Your Ref
WA/58/18/PL
Our Ref
PLAN-024161
Date
06/09/2018

Proposal: Erection of 2 No. detached dwellings, adaptation to existing crossover & new driveway.
Site: 1 Orchard Way, Fontwell, Walberton, BN18 0SH.
WA/58/18/PL

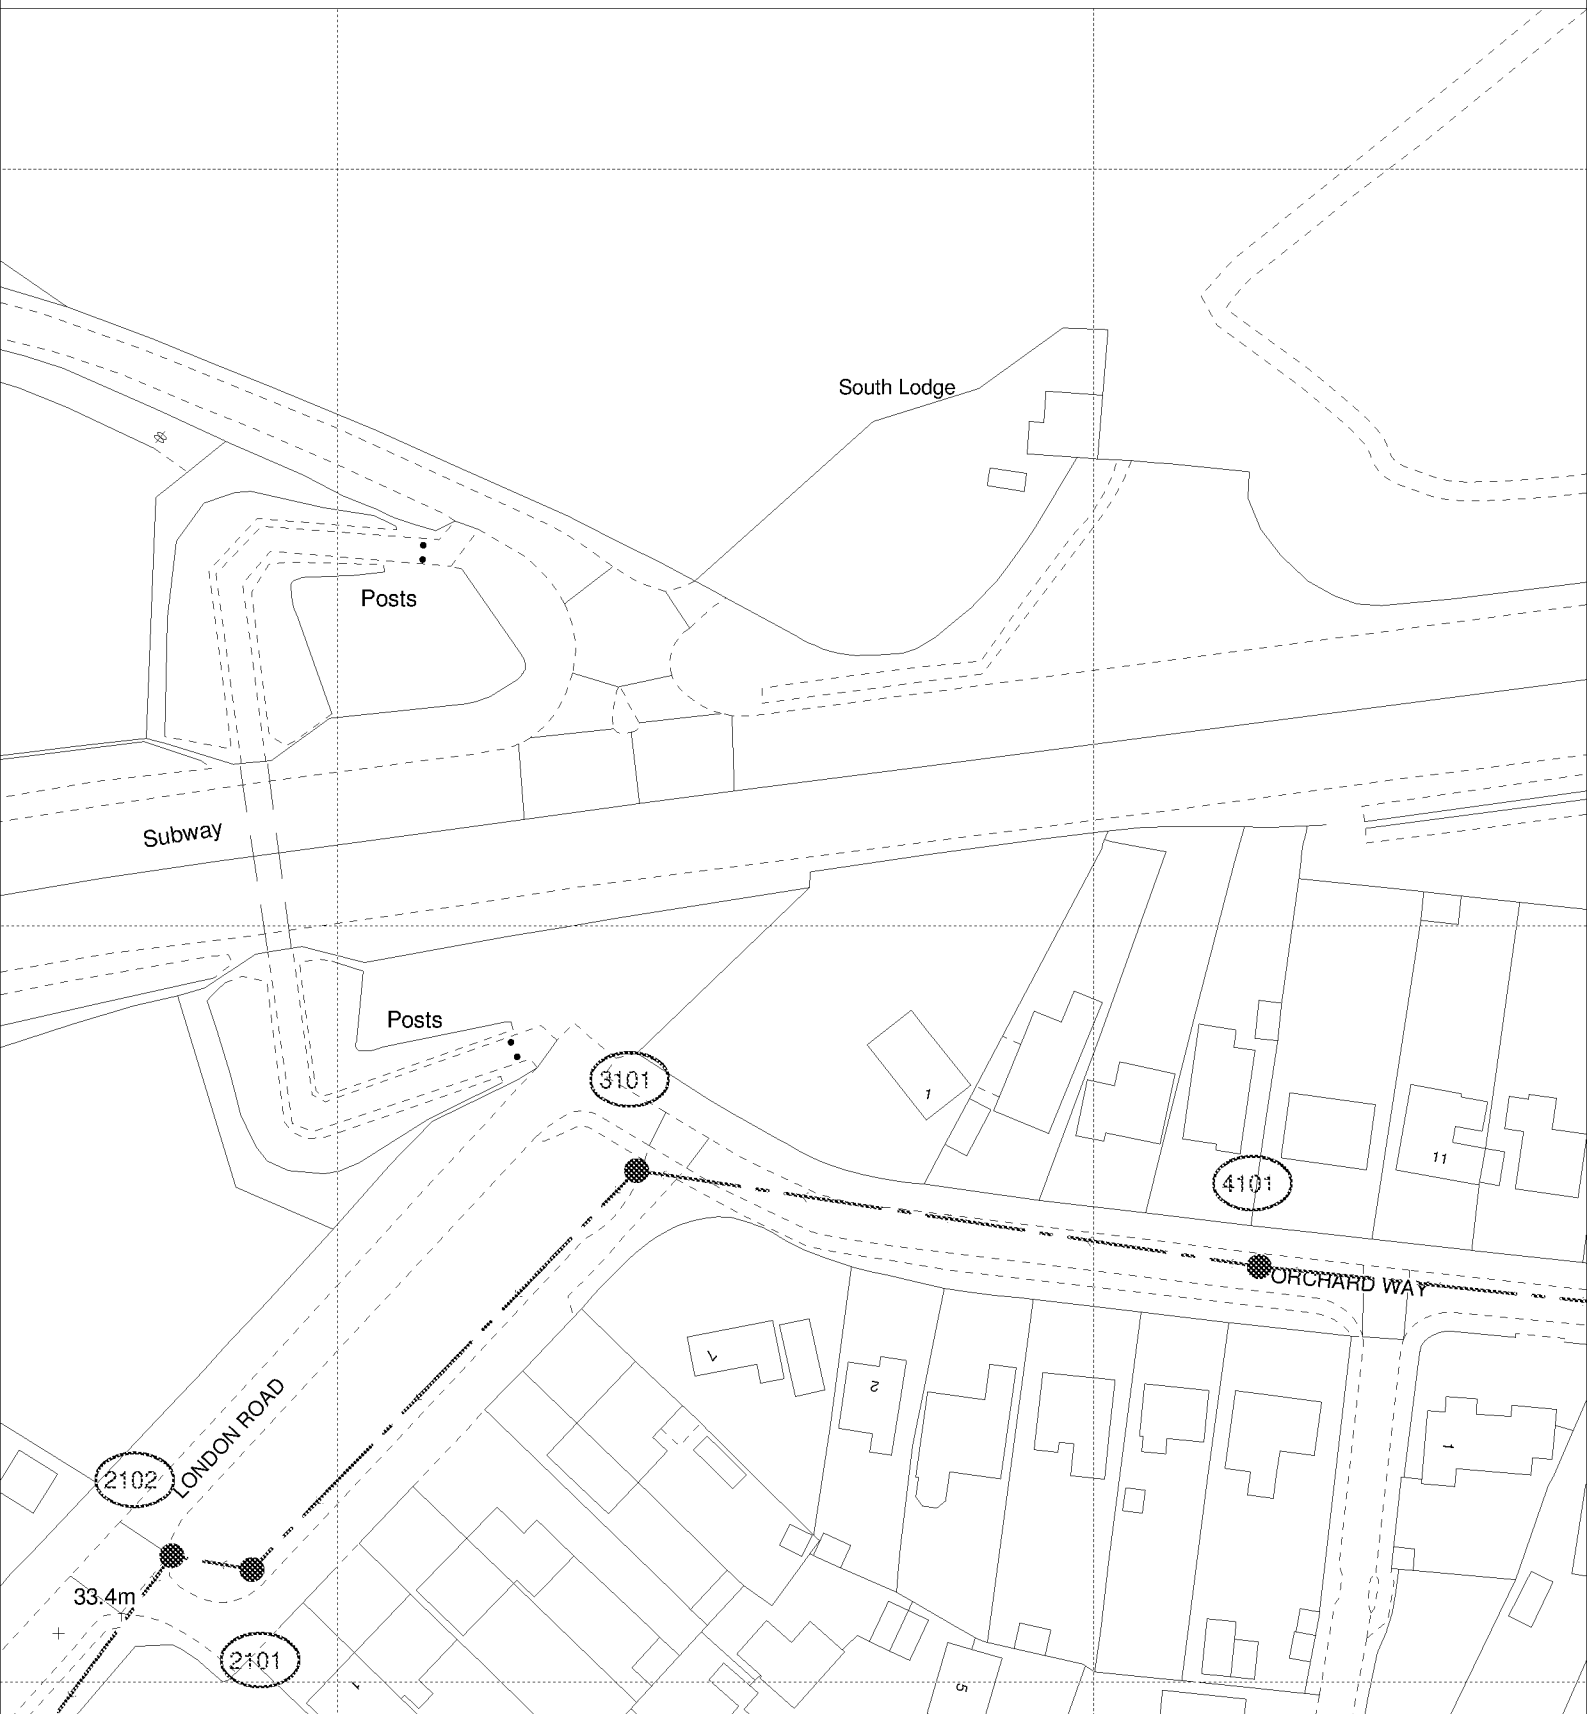
Due to surface water inundation issues in the Lidsey Catchment "The applicant is advised to adopt, where appropriate, the measures in the table "Practical measures to reduce the potential impacts of development".

Developer should look to protect the public sewerage system from inundation and infiltration, which contribute to flooding in unfavourable conditions.
